Proposal for cleaning up to ECE/TRANS/WP.29/GRRF/2016/31

I. Proposal

Figure 12, amend as follow:

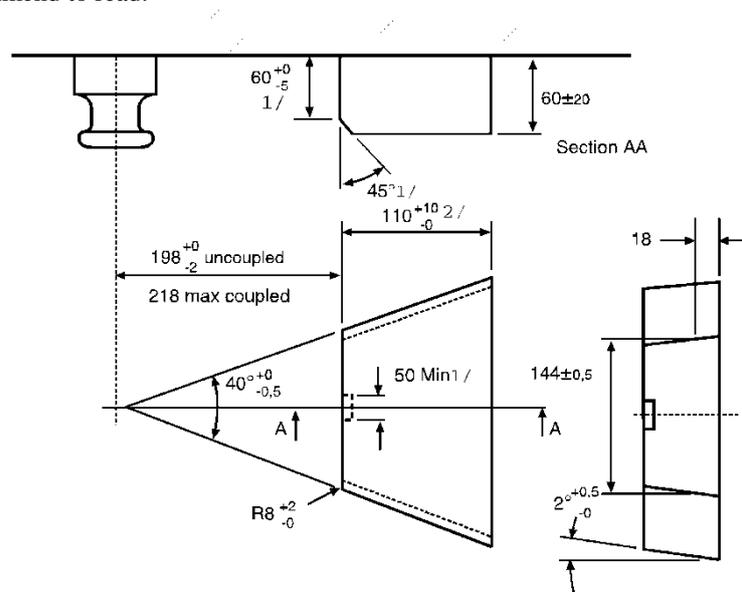
"...Change dimension sleeve bore diameter ~~Ø66H8~~ to **Ø60H8**..."
